**ALLEN & MAJOR
ASSOCIATES, INC.**

DRAINAGE REPORT

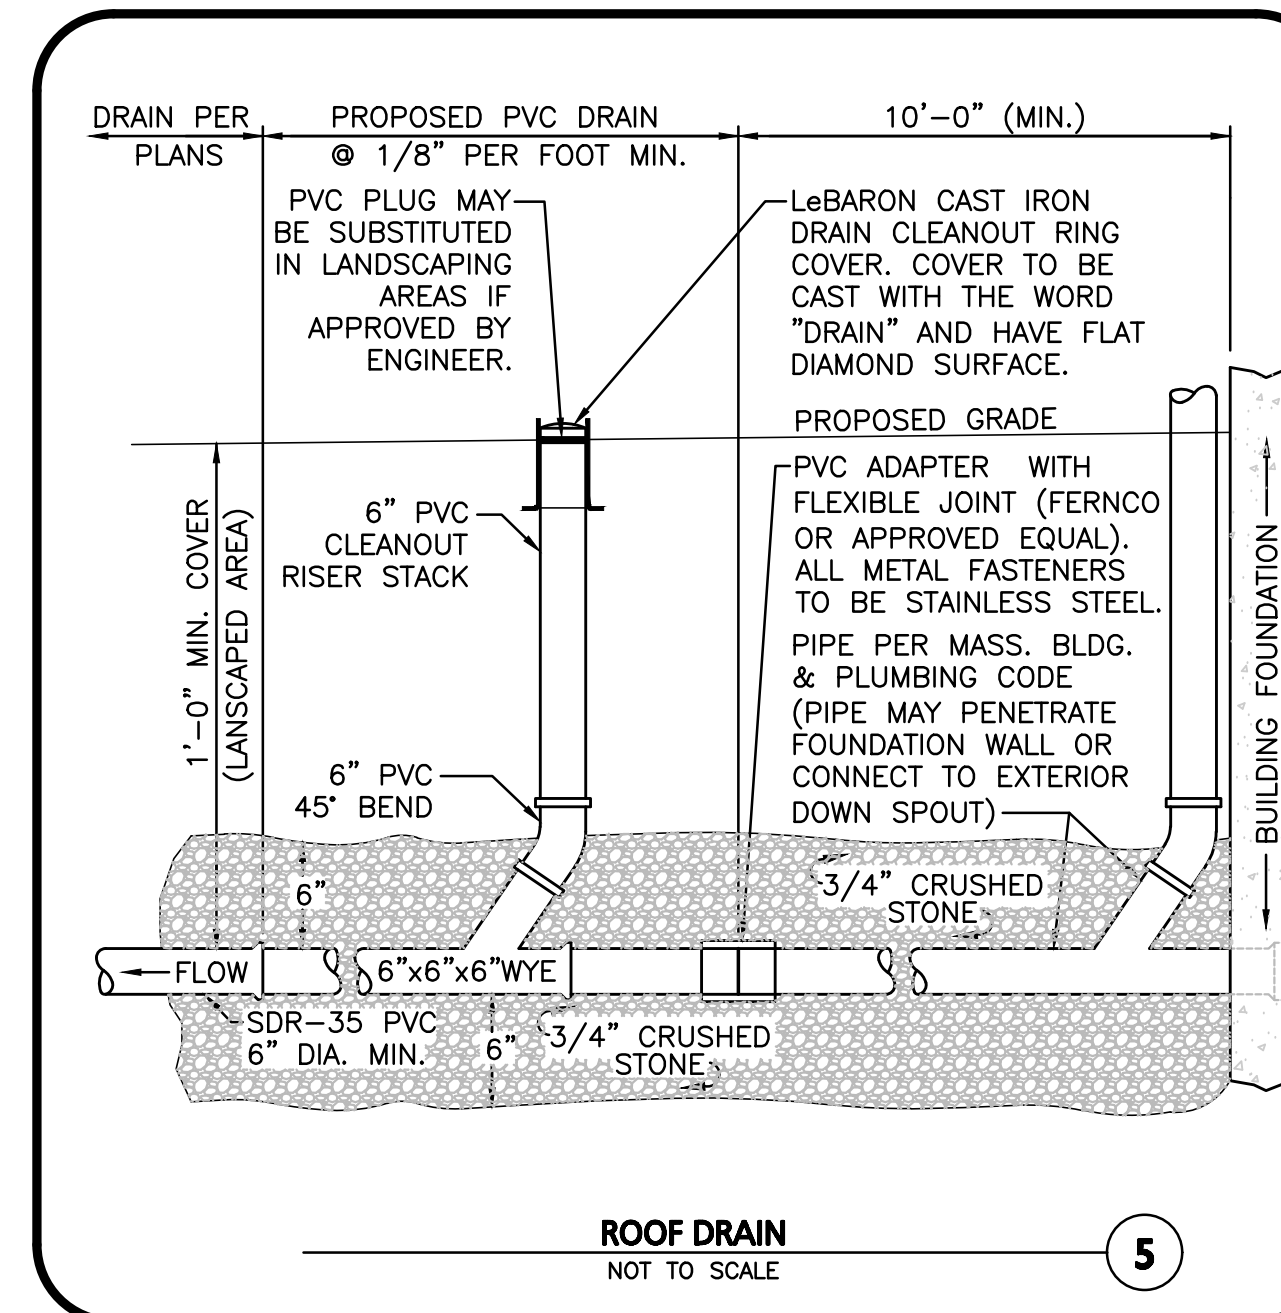
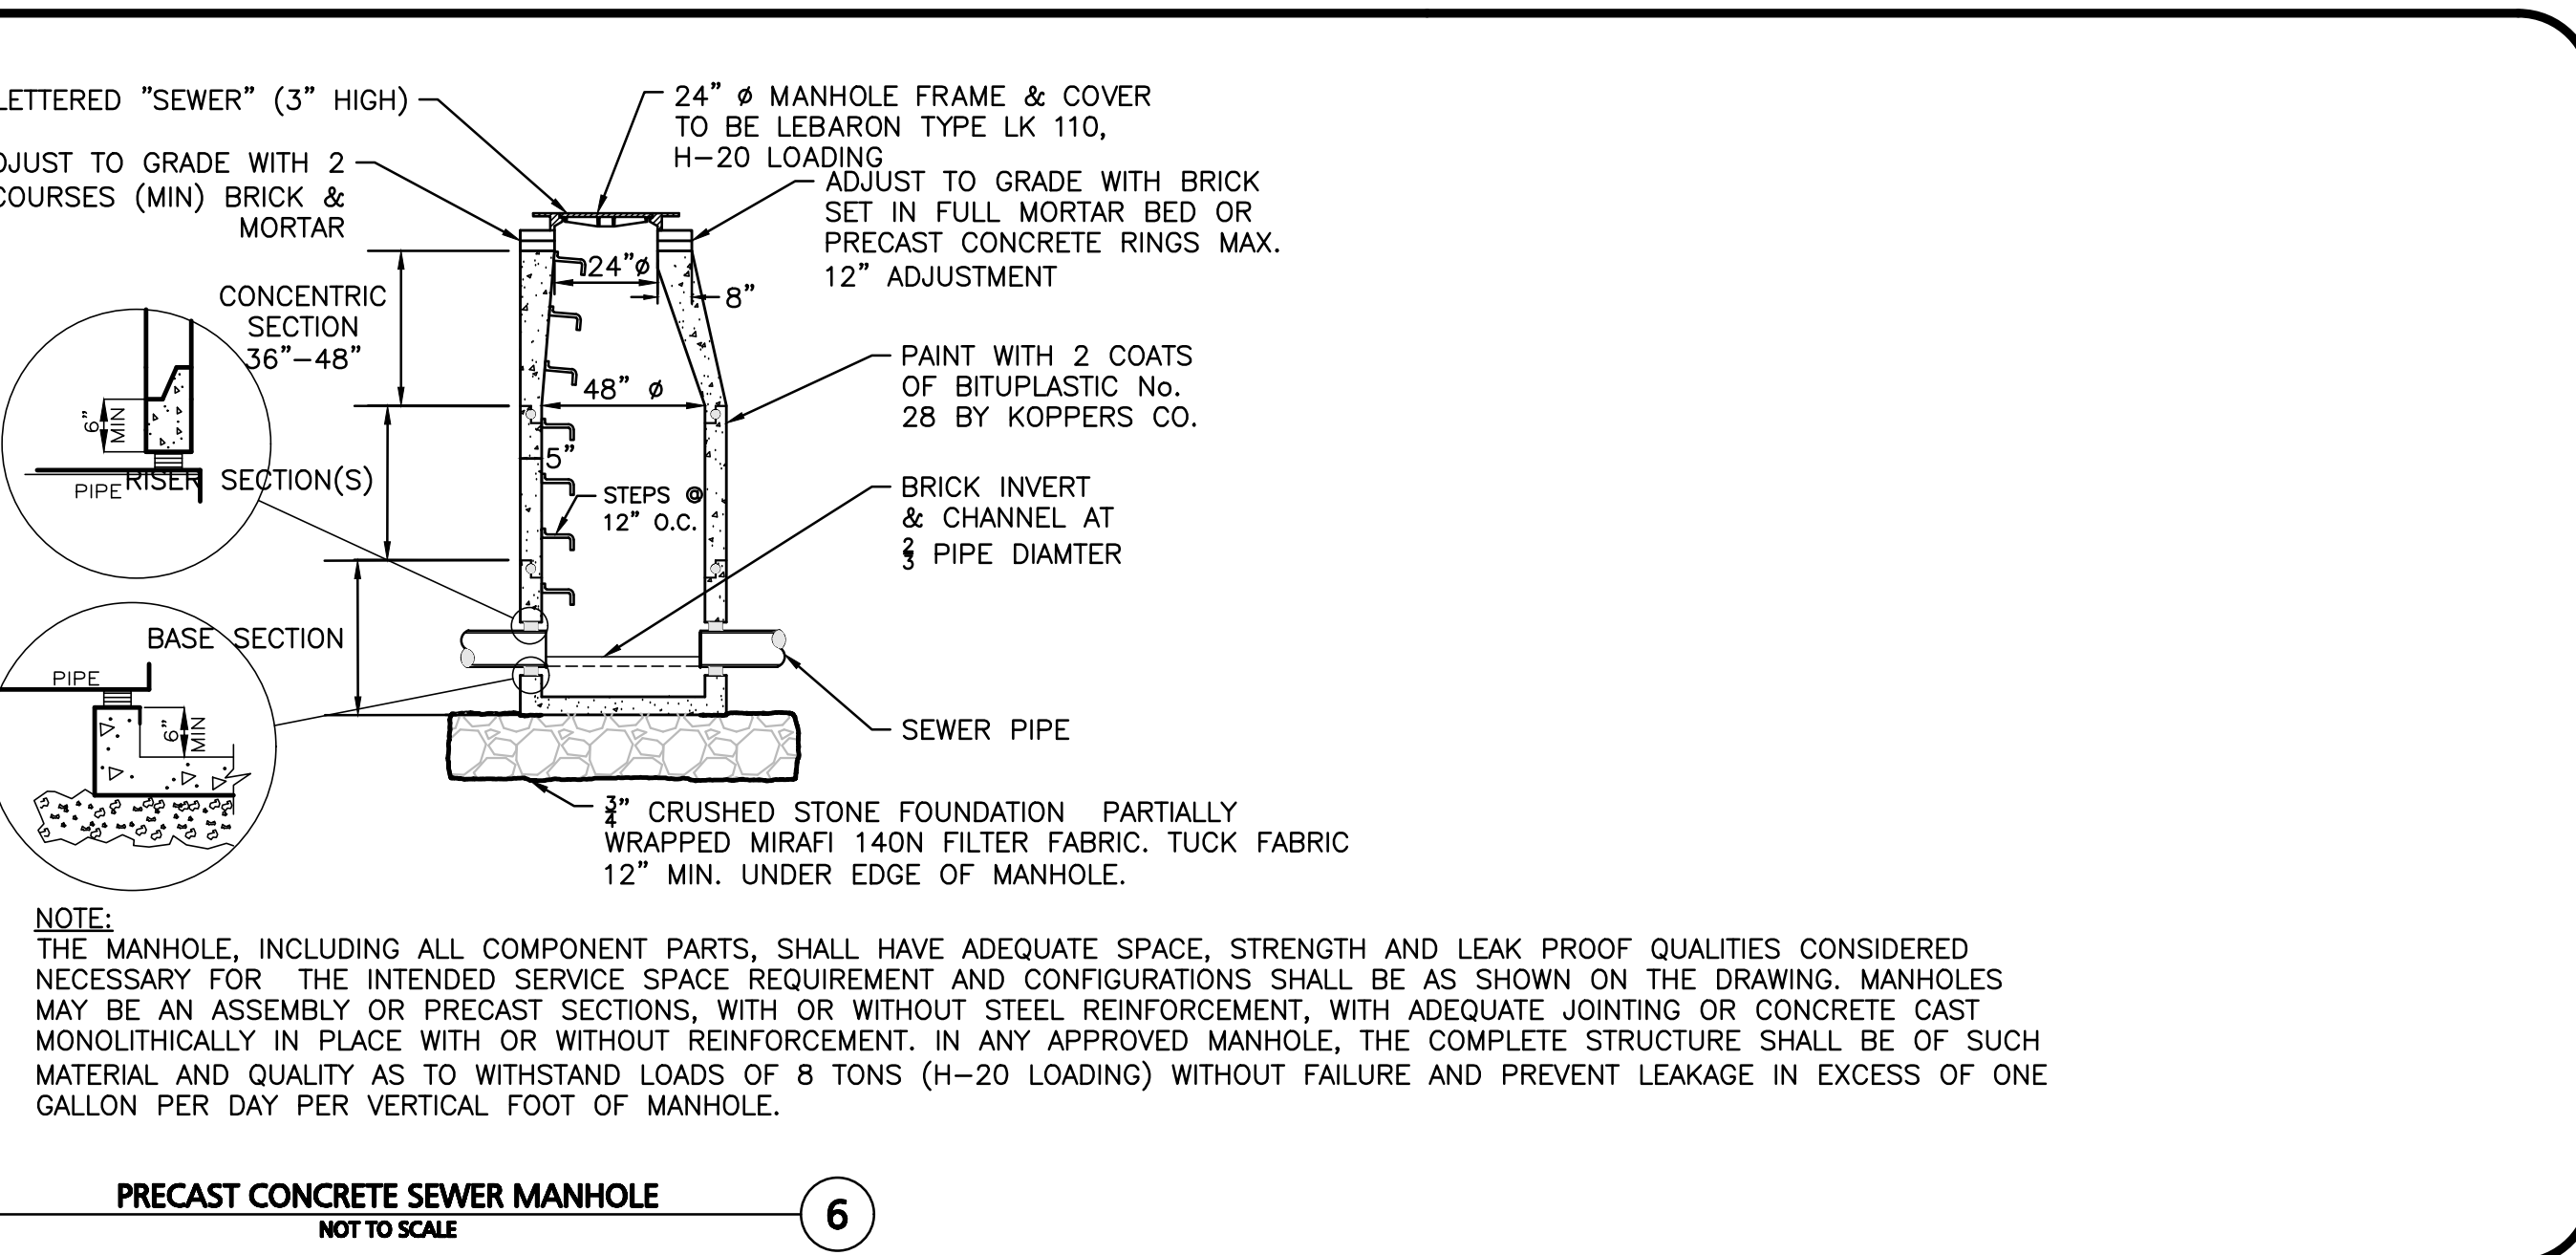
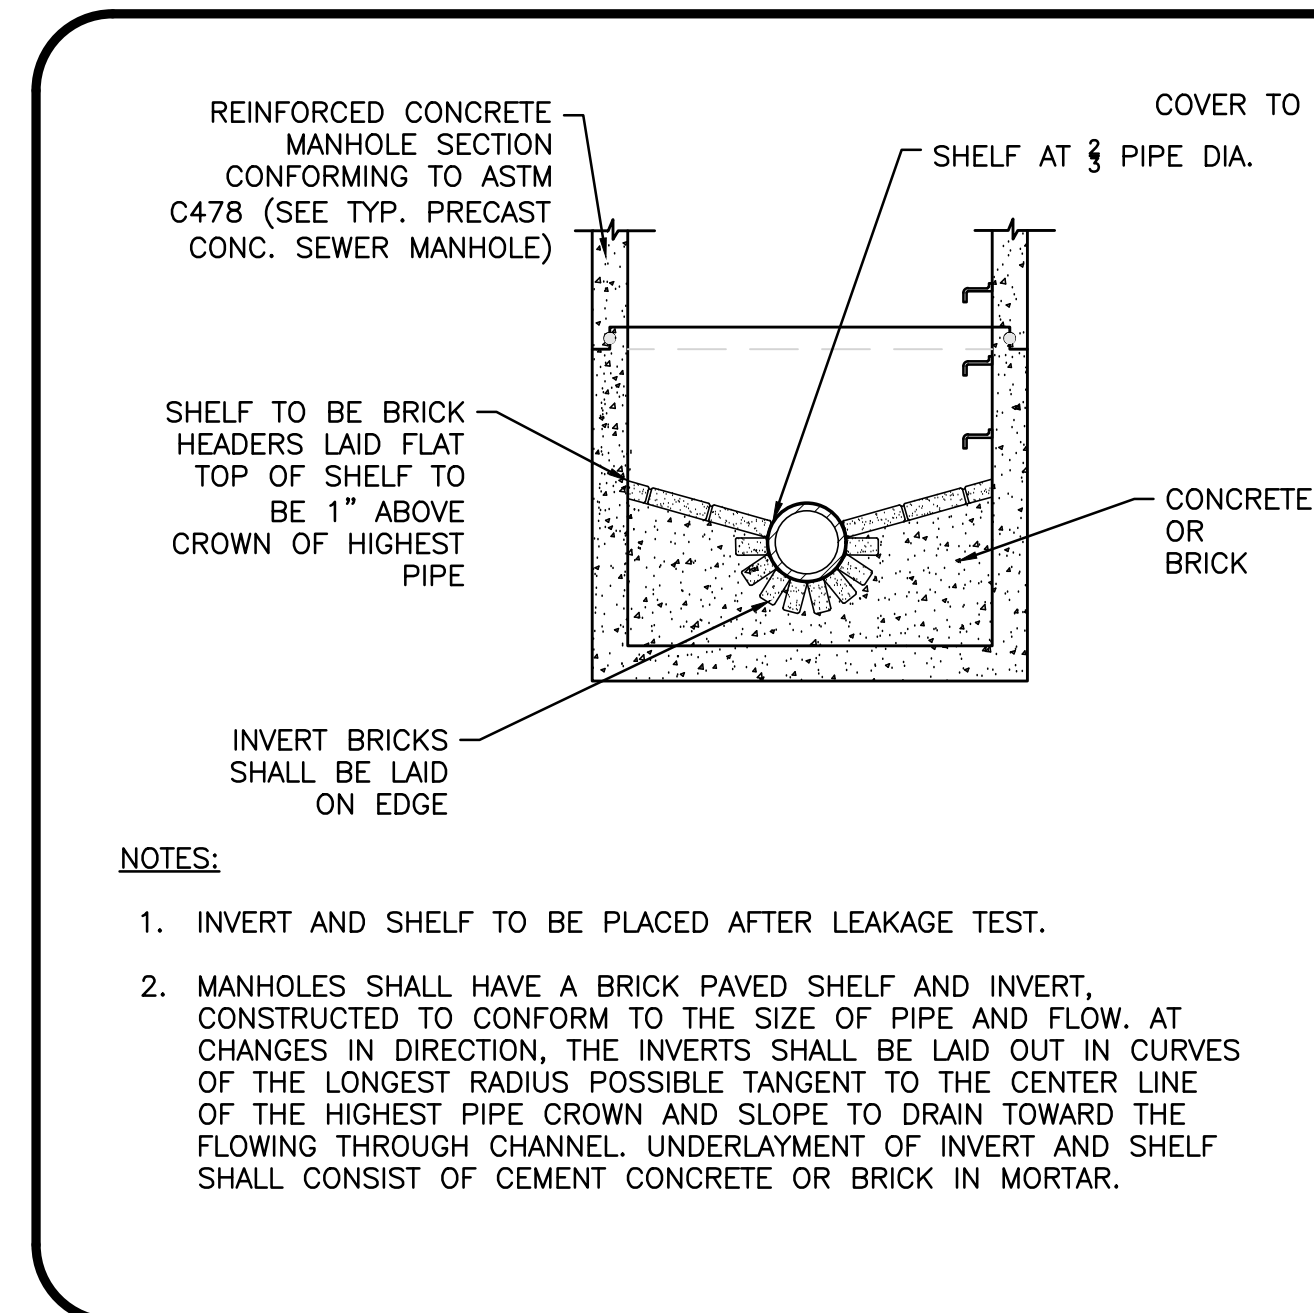
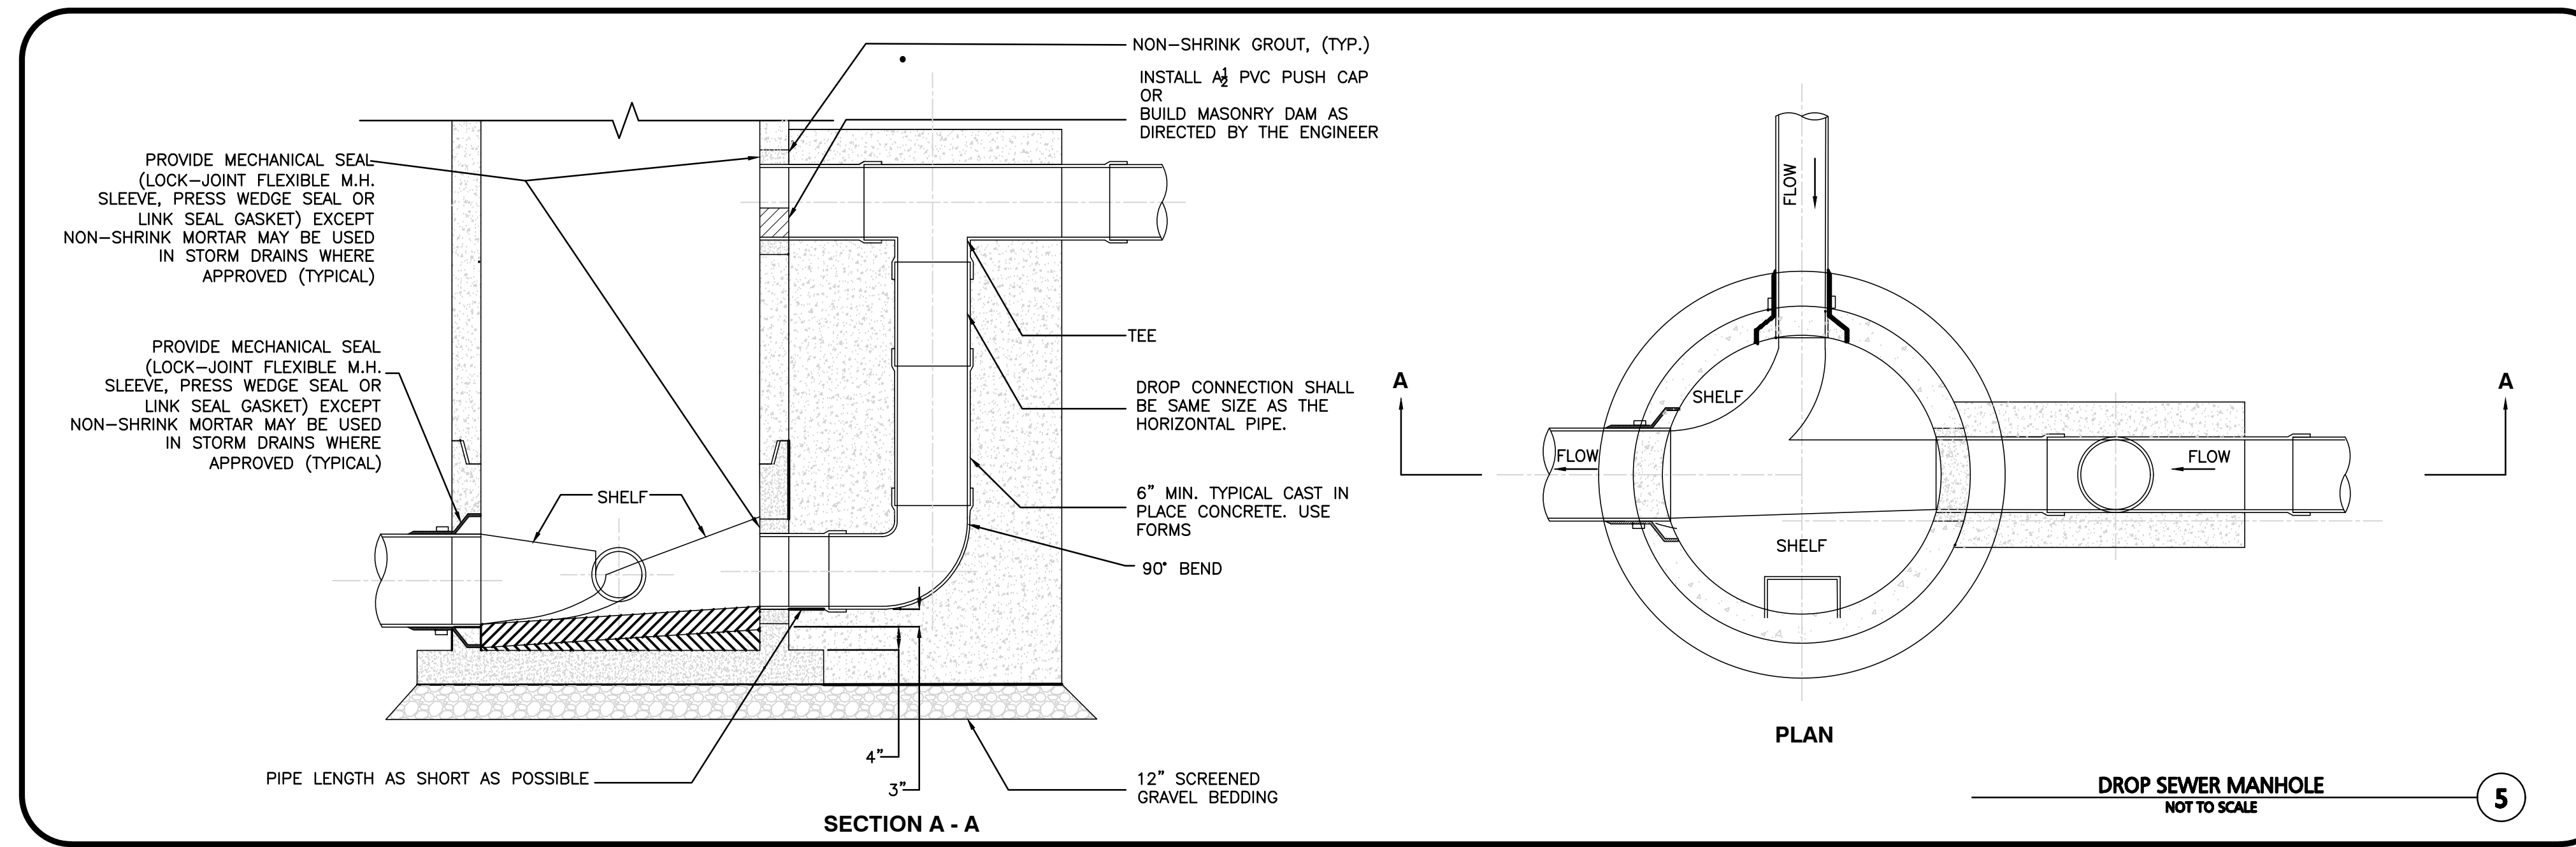
REV	DATE	DESCRIPTION
B	3/25/2024	REVISED PER TOWN COMMENTS
A	2/29/2024	REVISED PER TOWN COMMENTS
